# Technical Service Bulletin

**MODEL(S) T300/T300e Models**

**SUBJECT:** Scrub head lift pedal difficult to disengage from raised position.

**PURPOSE:** To improve scrub head lift pedal function, order Pedal Latch Upgrade Kit p/n 9014788.

Old style pedal latch

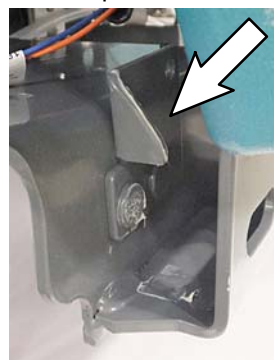
New kit pedal latch

The Pedal Latch Upgrade Kit includes the necessary parts to rework all model types (Disk, Orbital and Cylindrical).
